# Reviewer 1

## A. General Comments

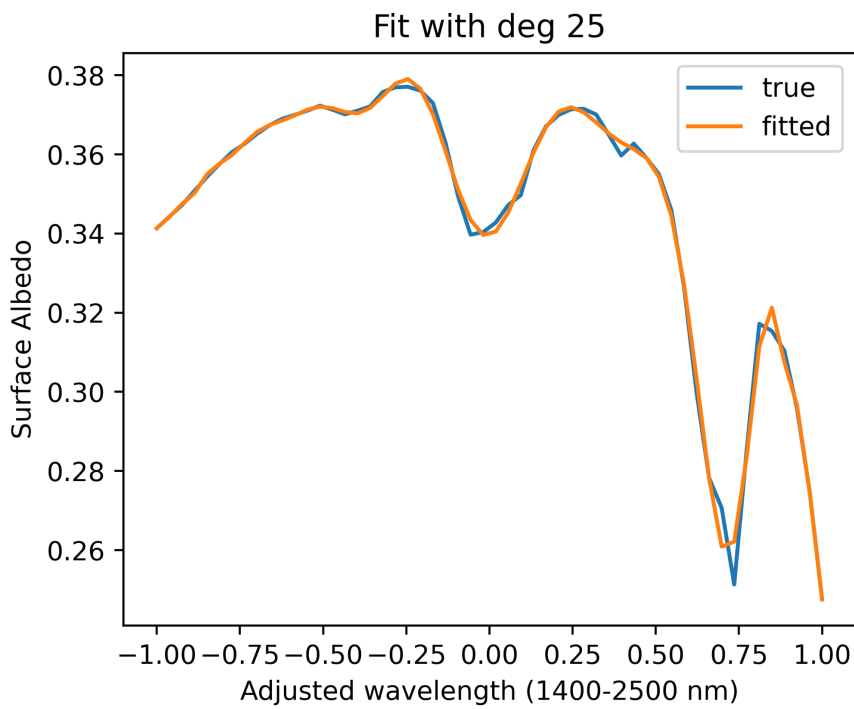
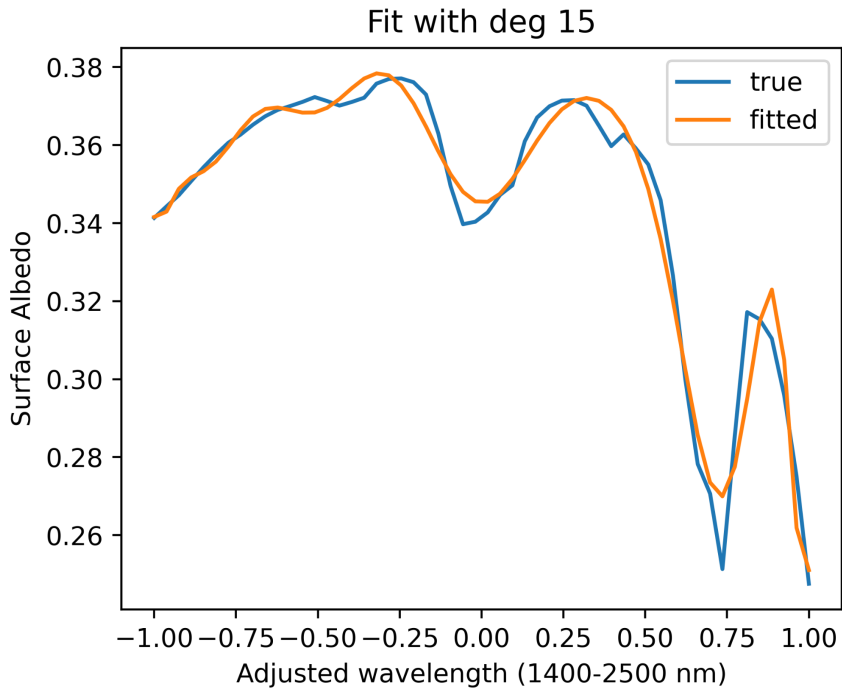
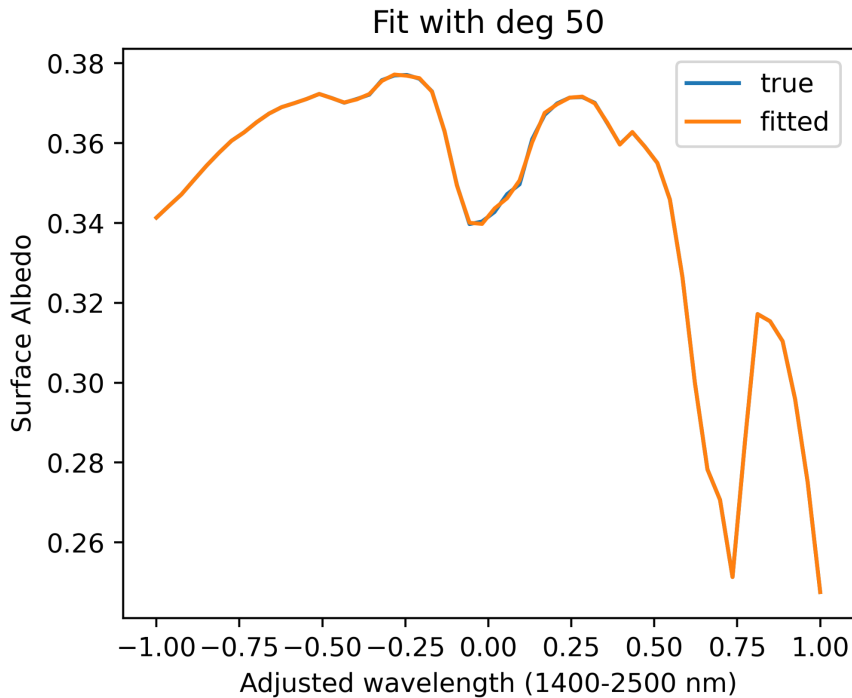
Surface features and polynomial degree: A key outcome of the study is the need for a very high degree of a polynomial to sufficiently accurately describe surface features. However, the use of a polynomial of degree 50 makes me uneasy. Can you show with a direct polynomial fit to the underlying surface albedo data of the ECOSTRESS spectral library before using it in your forward model and without any spline interpolation that such a polynomial degree is needed? I would also expect that a high polynomial degree will lead to an increased number of non-converging retrievals when not carefully choosing their a priori value and a priori covariance; can you please elaborate on your choice. As you show in the paper, a high polynomial degree will increase the retrieval uncertainty for methane. At the same time the correlation with methane will increase so that you risk that the methane absorption will be taken out by the polynomial. Did you have a look at the correlation coefficients ?

We applied a polynomial degree of 50 as an illustration of how it could change bias and precision error. Over most surfaces, a polynomial degree of 25 seems adequate to significantly reduce the retrieval error (both bias and precision error combined).

The polynomial fits for an example surface (construction concrete) are shown in the following figures. The surface albedo in this demonstration is without any spline interpolation. Legendre polynomials were used and the range of wavelength is 1400-2500 nm. Even when the x-axis is adjusted to be in between -1 to +1 to make the fit easier, we clearly observed that high degrees such as 25 or 50 were needed to capture the surface albedo variations.
